**WCAP-16996-P, "Realistic LOCA Evaluation Methodology Applied to the Full Spectrum of Break Sizes  
(FULL SPECTRUM LOCA Methodology)"  
Requests for Additional Information – (Non-Proprietary)  
RAIs 46 – 58, 75, and 77**

**October 2013**

Westinghouse Electric Company LLC  
1000 Westinghouse Drive  
Cranberry Township, PA 16066

**Figure 1: Comparison of WCOBRA/TRAC-TF2  $T_{CHF}$  Criterion with Various Correlations and Experimental Data**

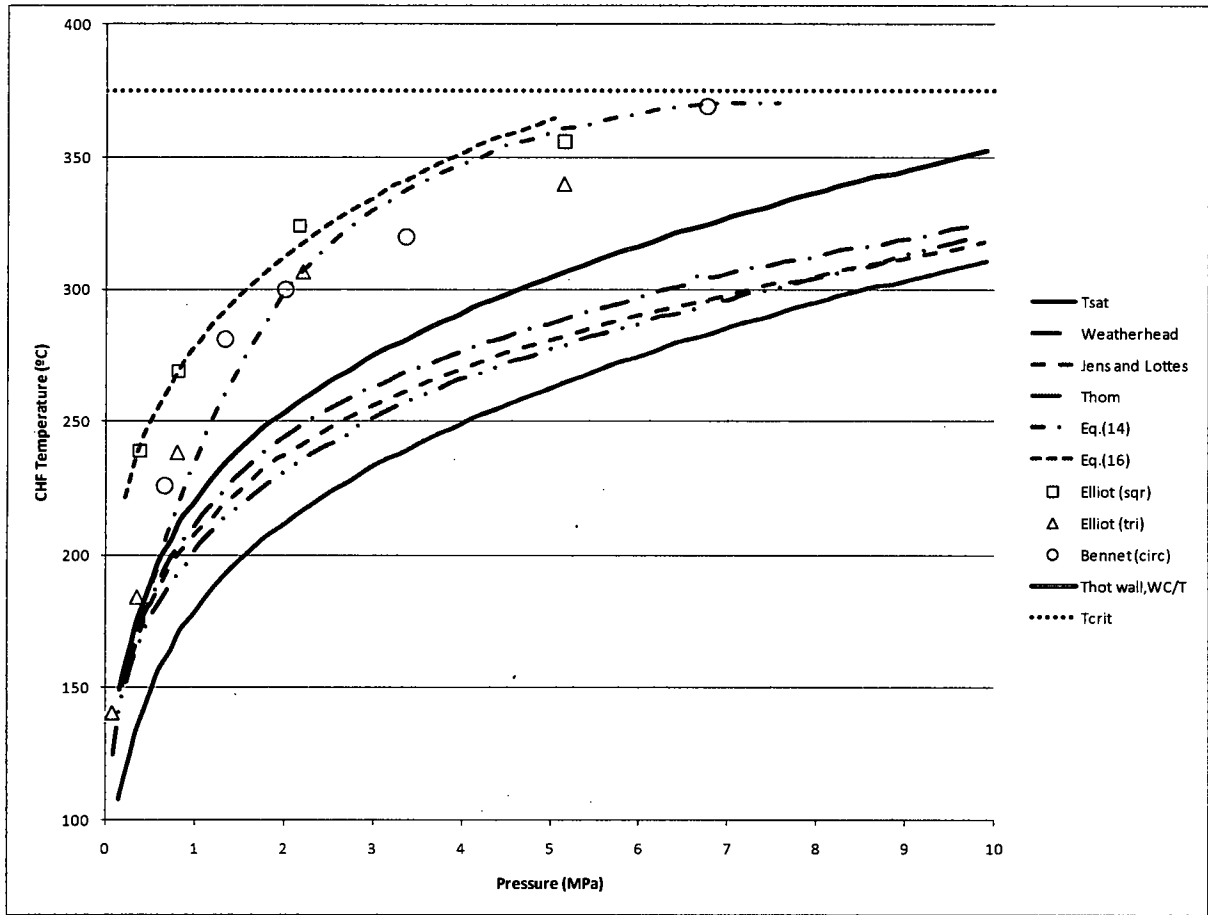
Carbajo (Carbajo, J., 1985 [4]) noted that the most significant contributor to  $T_{CHF}$  was the pressure. He compared  $T_{CHF}$  to various correlations and experimental data as a function of pressure. This comparison is presented as Figure 1, with the addition of the  $T_{CHF} \approx T_{SAT} + 75^\circ F$  criterion.
